STATE OF CONNECTICUT CONNECTICUT SITING COUNCIL

APPLICATION OF CELLCO PARTNERSHIP : DOCKET NO. 484

RESPONSES OF CELLCO PARTNERSHIP D/B/A VERIZON WIRELESS TO CONNECTICUT SITING COUNCIL PRE-HEARING INTERROGATORIES

ATTACHMENT 1

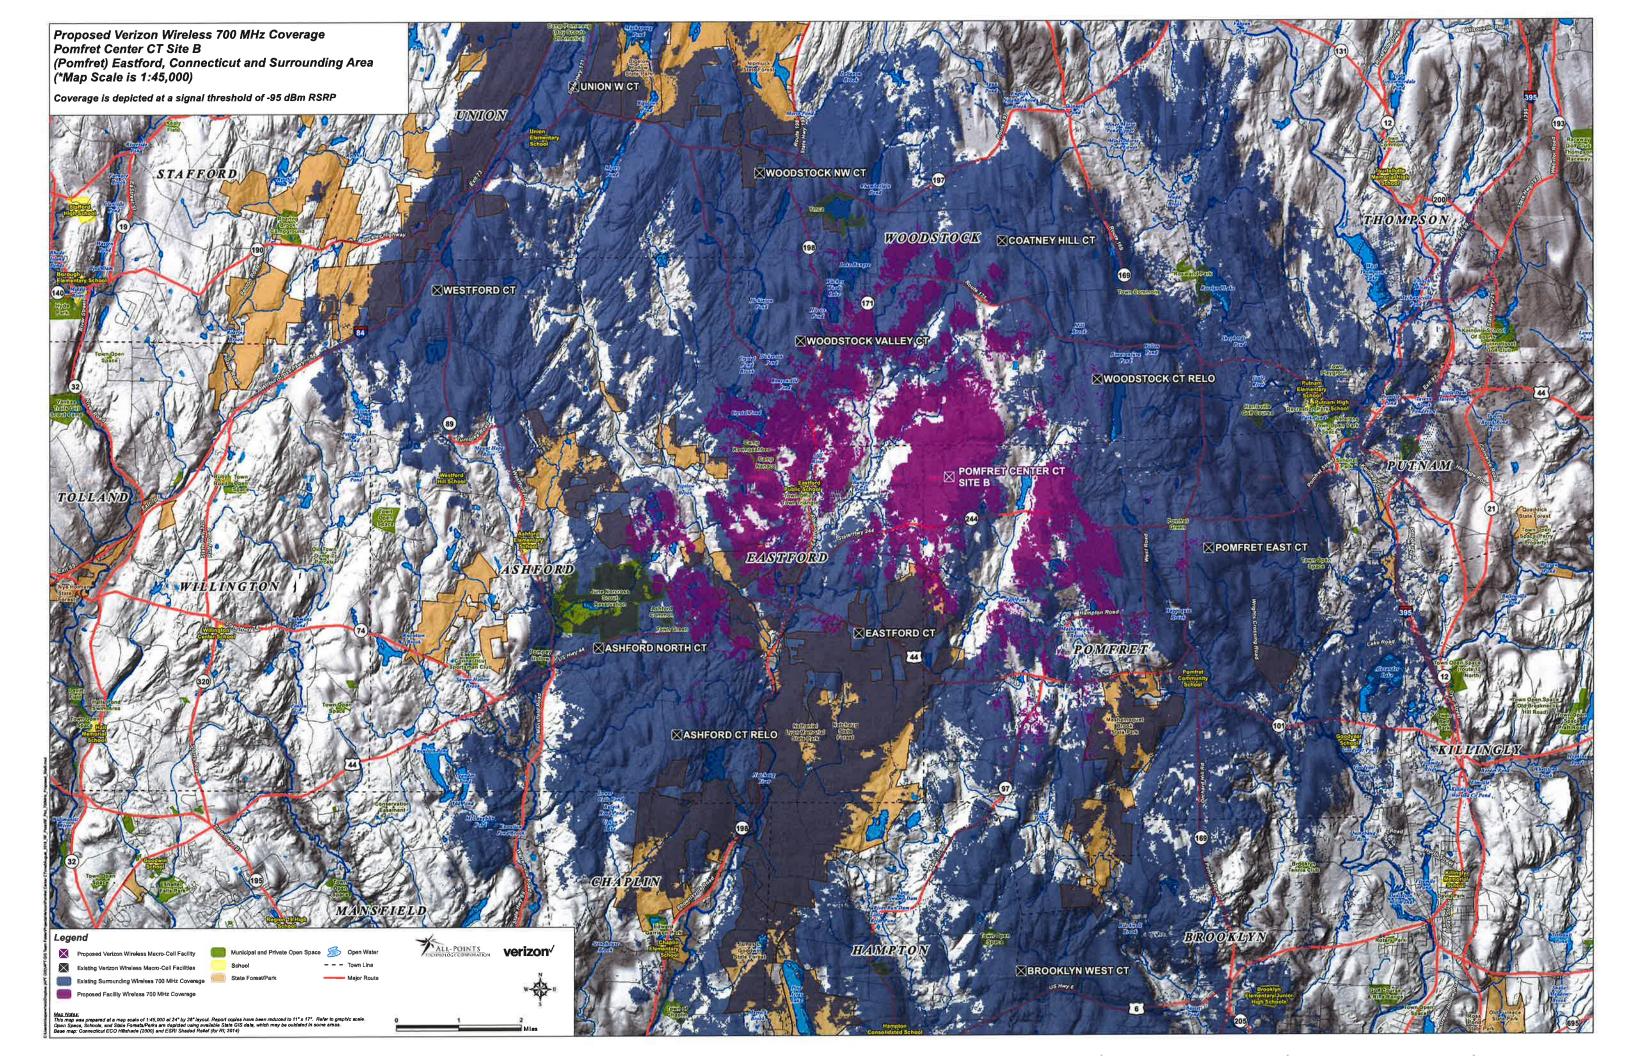
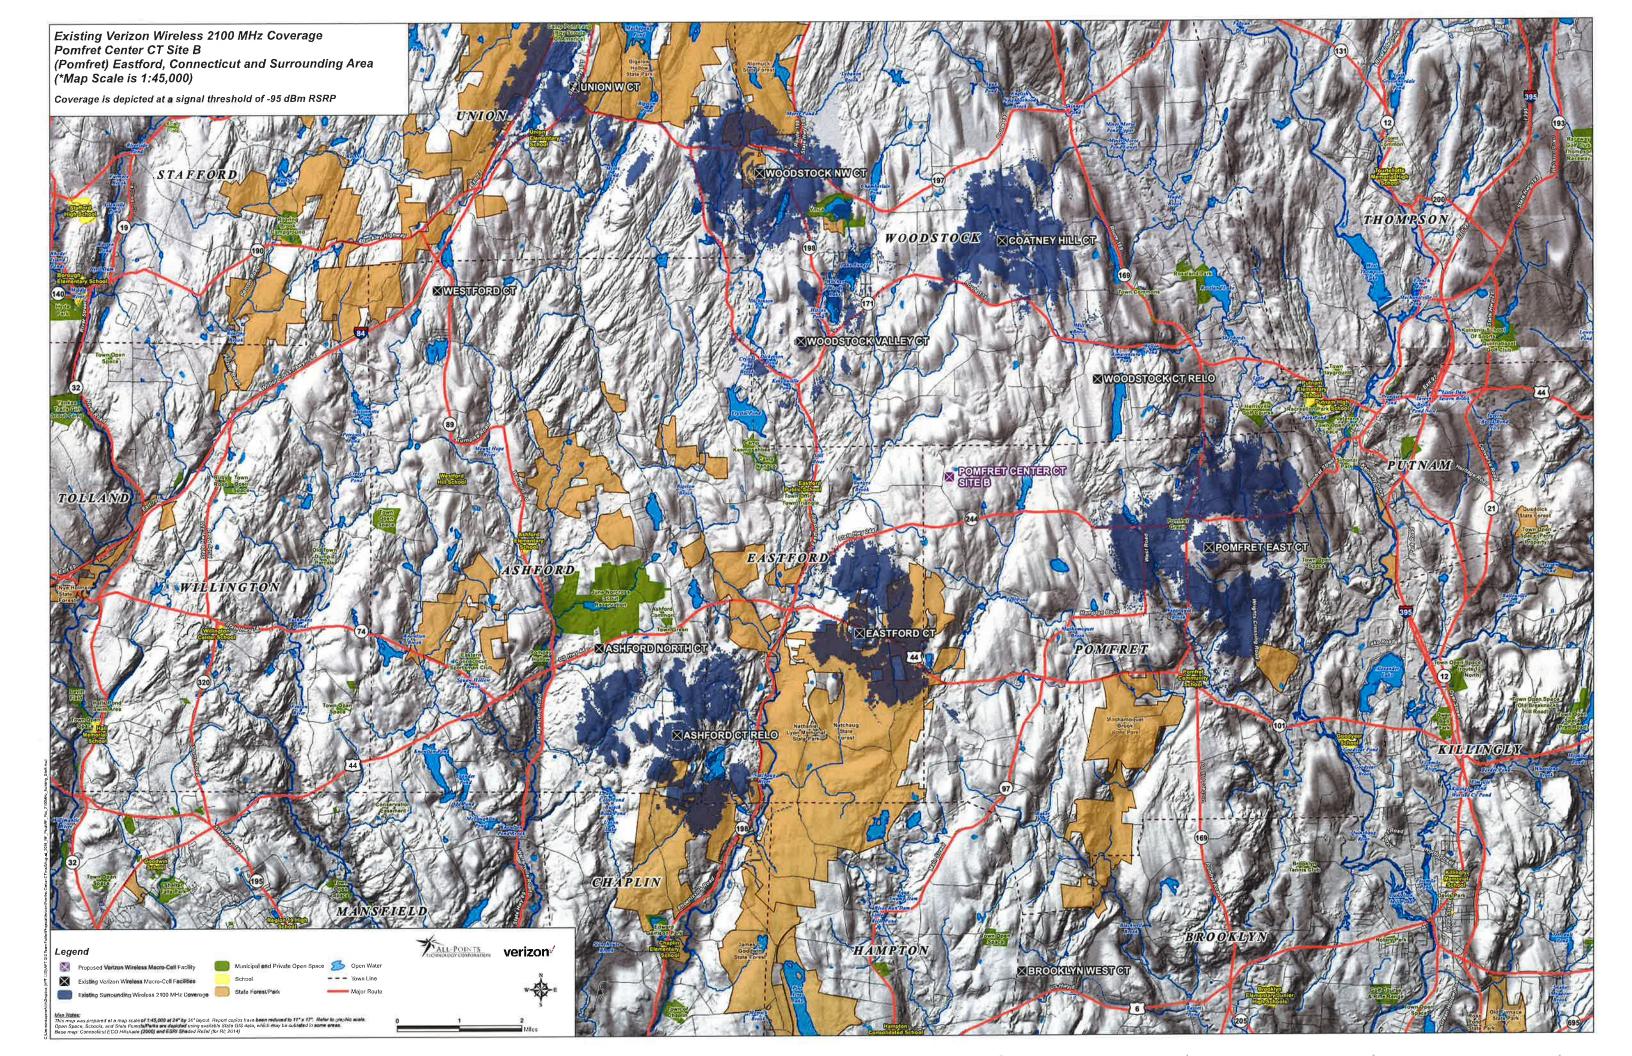
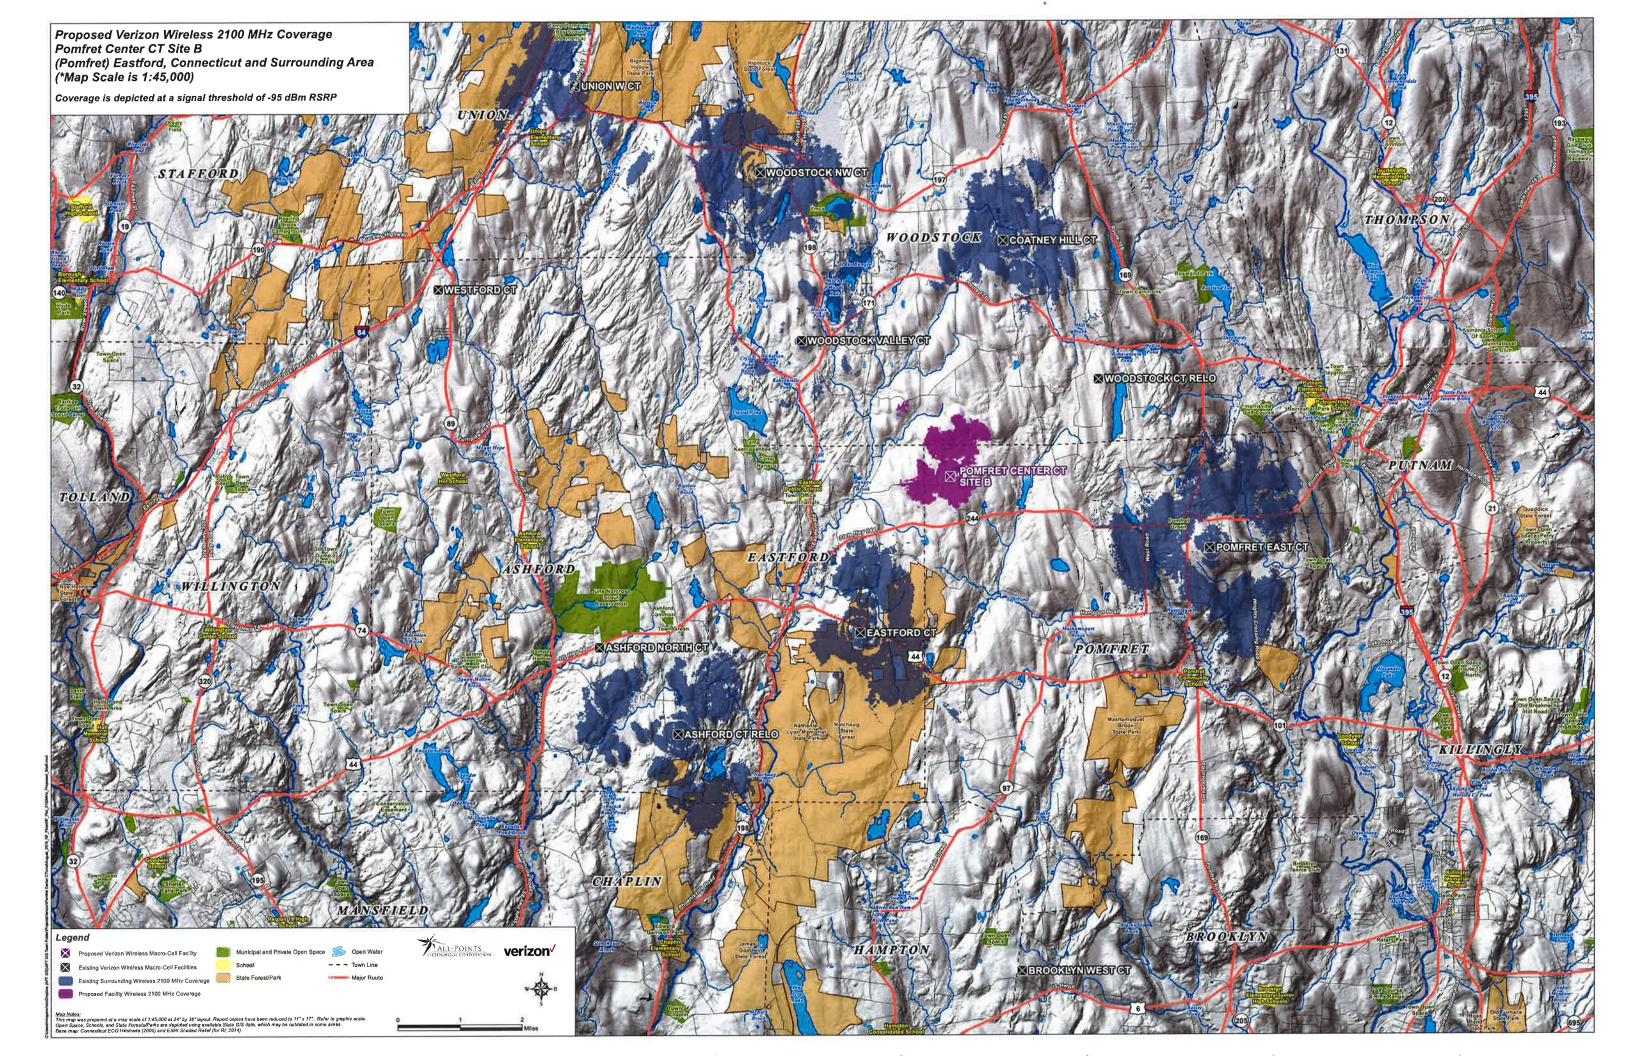
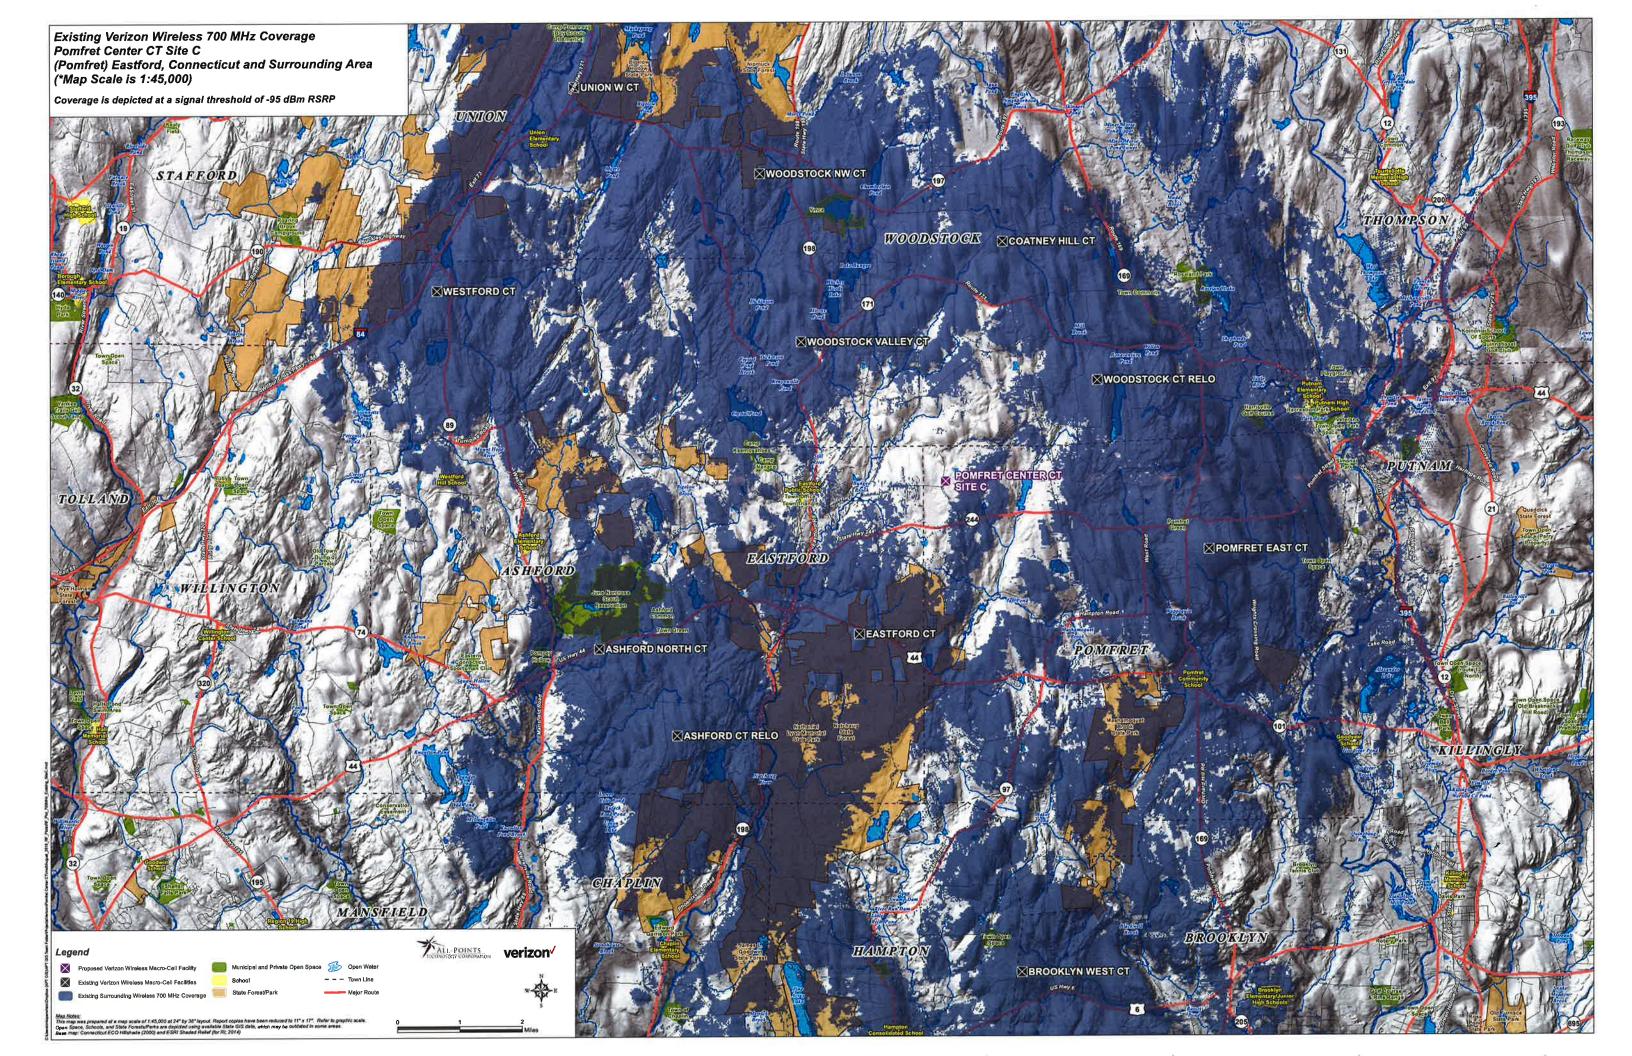
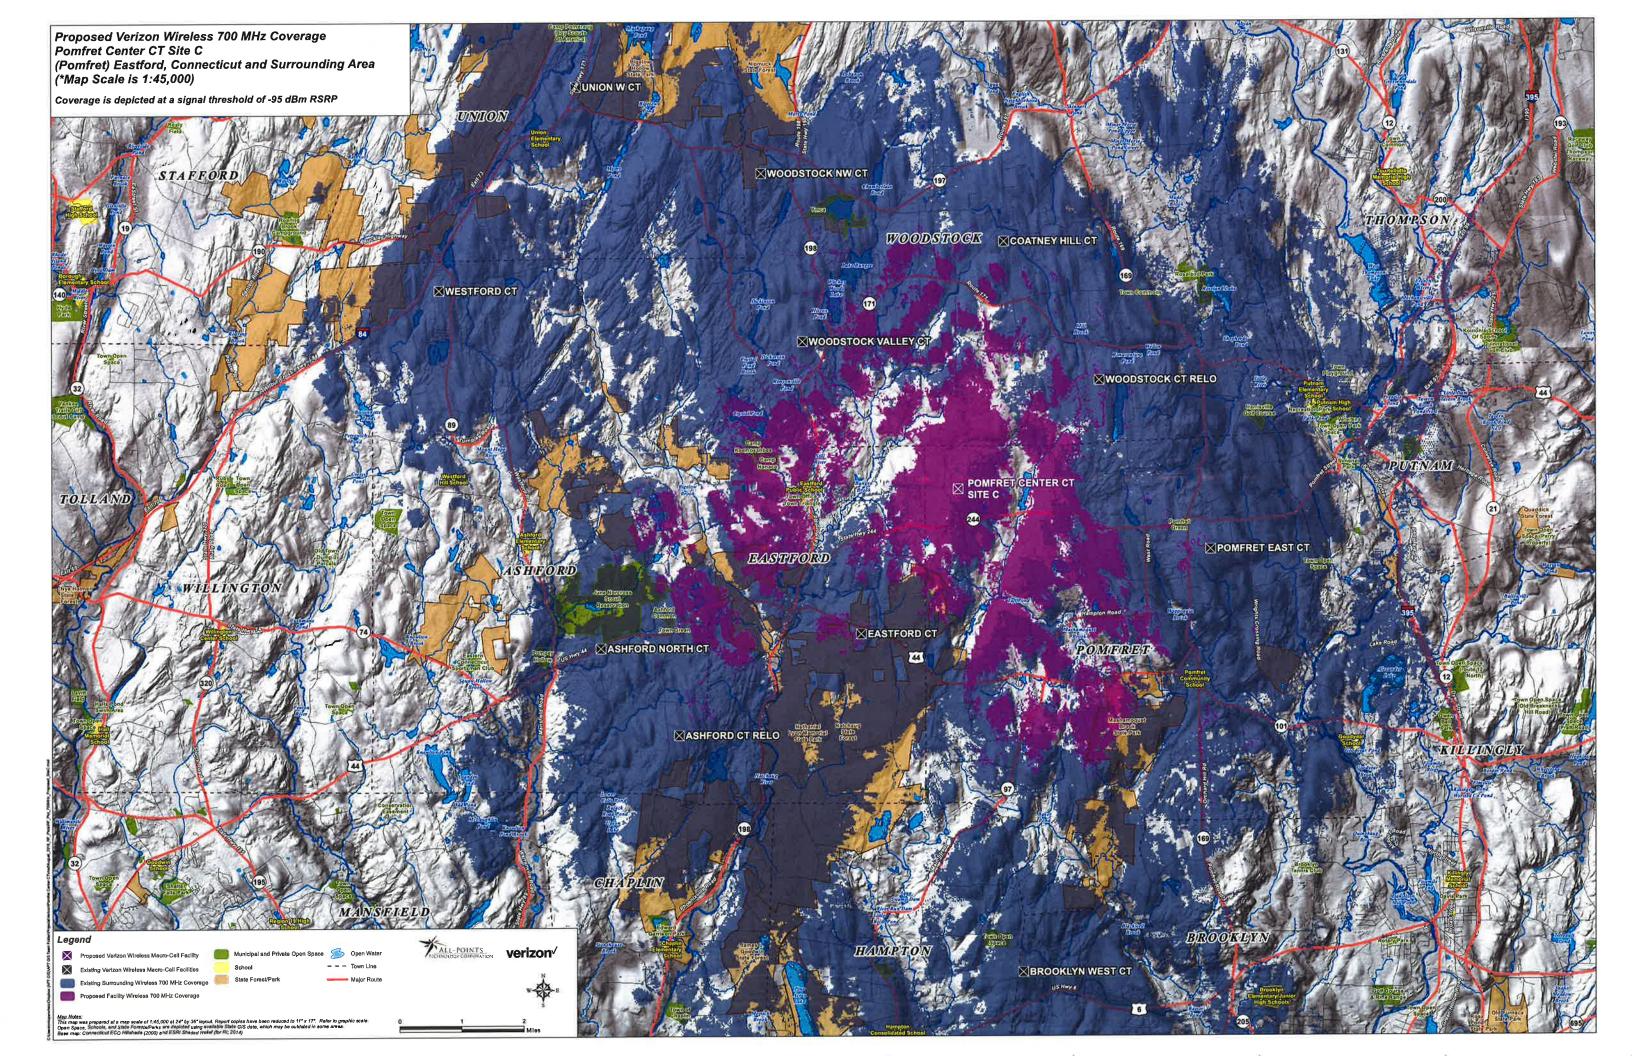
Referring to Application Tab 6 - 700 MHz coverage plots, the coverage plots do not appear to show any 700 MHz service from the "Eastford CT" site. Is this Cellco site active? What services is it providing?

Yes, the Eastford CT site is currently active. Coverage from Cellco's Eastford CT and its newly constructed Woodstock Valley cell sites was inadvertently excluded from the coverage plots that Cellco included in the Application. Revised coverage plots, showing 700 MHz and 2100 MHz service from the all of the adjacent cell sites, including Eastford and Woodstock Valley, are included in Attachment 1 of these responses.
